POWER PLANT - NACELLE - POWERPLANT - REPLACEMENT OF THE TAI VALVE - CATEGORY CODE 7 -
MOD.NAC-71-0166

V2500-NAC-71-0166

SERVICE BULLETIN

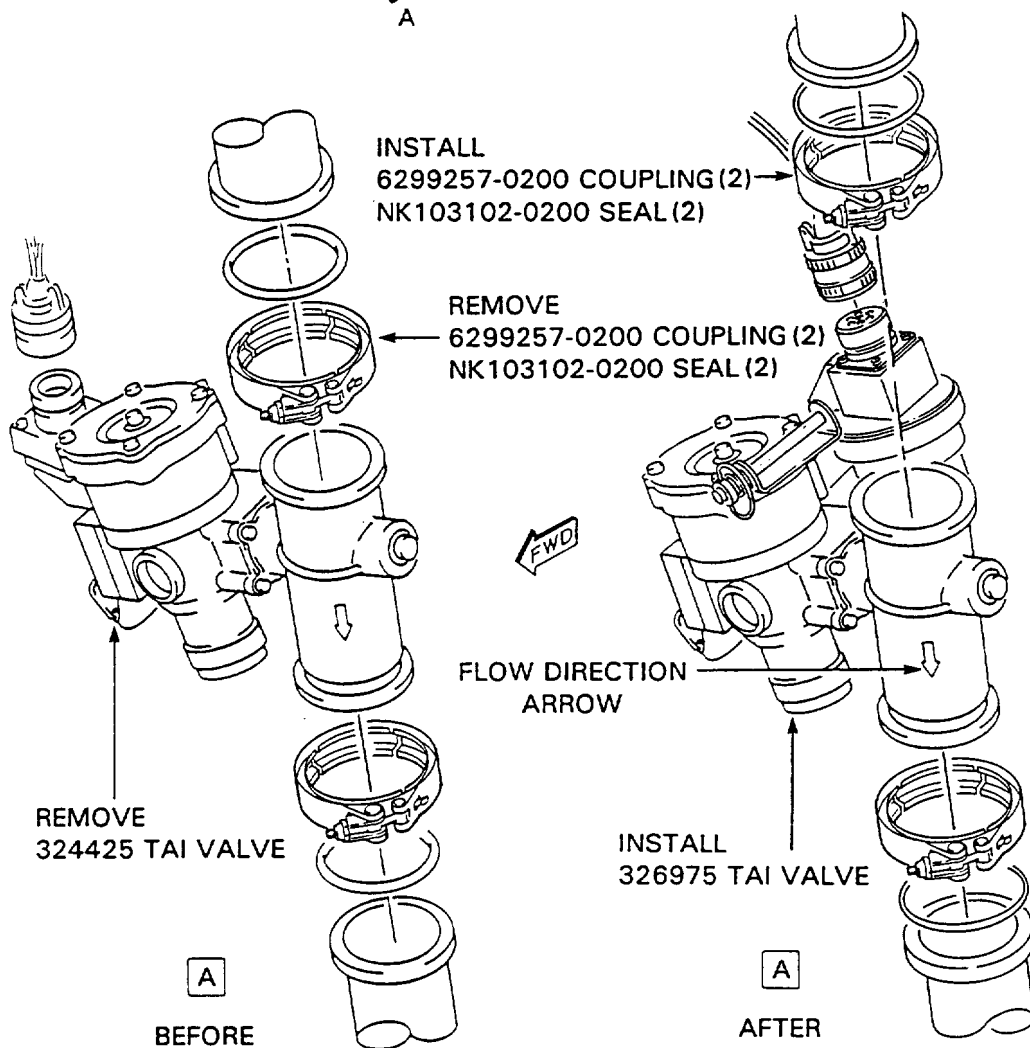
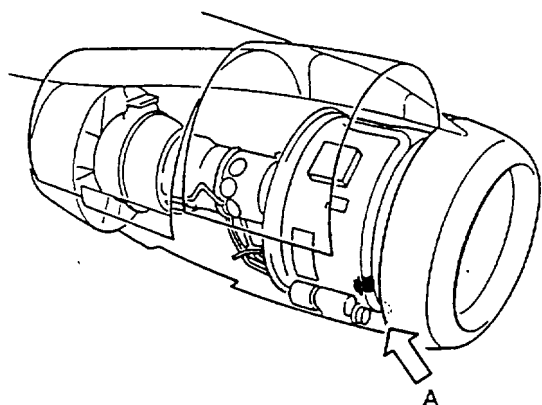
(11) Connect the 4000DN-A electrical connector to the 326975 TAI valve.

(12) Position the electrical harness to obtain maximum clearance between itself and adjacent hardware/structure. Torque the nut at clipping point CP1206 to between 36 to 45 lbfin (4 to 5 Nm)

REPLACEMENT OF T.A.I. VALVE
FIG.1

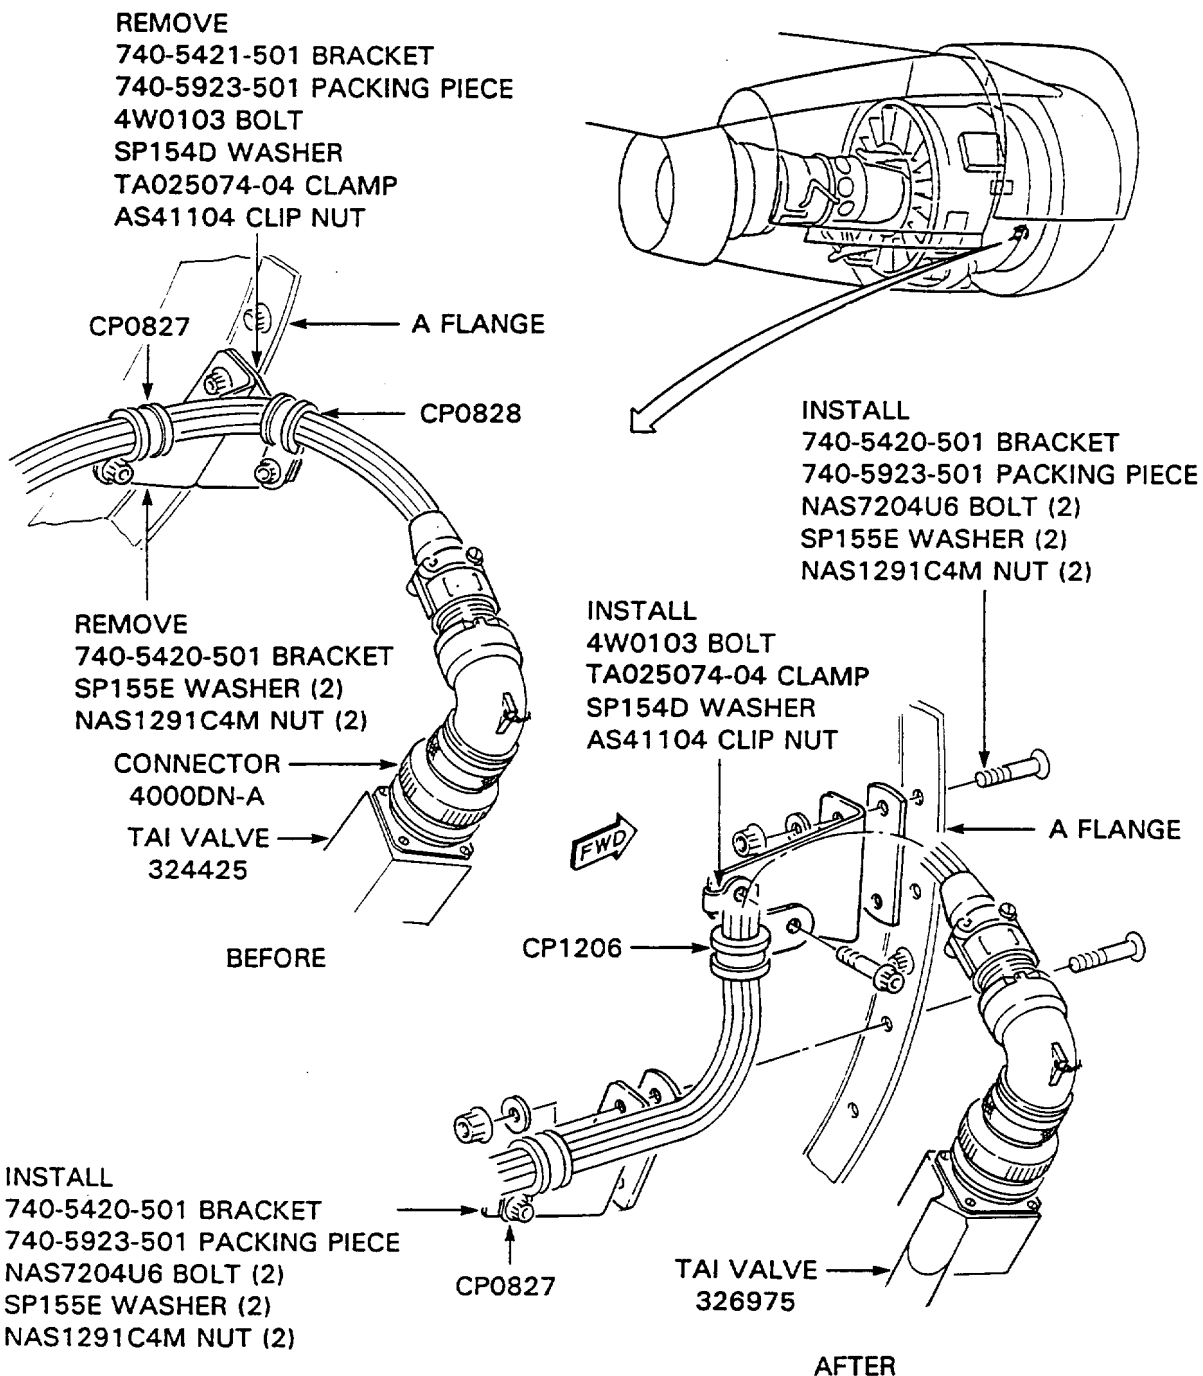
- (a) The TAI valve is removed and replaced with a new valve. An existing bracket is made redundant and a new one is introduced to accommodate the routing change of the cable harness to the new TAI valve.

- (1) Disassemble clipping point CP0828 (Refer to Figures 1 and 2.)
- (2) Remove the two NAS1291C4M nuts and SP155E washers to release the 740-5421-501 bracket, 740-5923-501 packing piece and 740-5420-501 bracket from the 'A' flange of the fan case. Do not remove the bolts from the flange.
- (3) Install the 740-5420-501 bracket and 740-5923-501 packing piece back to 'A' flange with the two NAS1291C4M nuts and SP154D washers. Torque the nuts 85 to 105 lbfin (10 to 12 Nm).
- (4) Install the 740-5420-501 bracket and 740-5923-501 packing piece to 'A' flange as shown with the two NAS7204U6 bolts, two SP155E washers and two NAS1291C4M nuts. Torque the nuts 85 to 105 lbfin (10 to 12 Nm).
- (5) Assemble clipping point CP1206 to bracket 740-5420-501 as shown with the 4W0103 bolt, TA025074-04 clamp, SP154D washer and AS41104 clip nut. Hand tighten bolt at this stage.
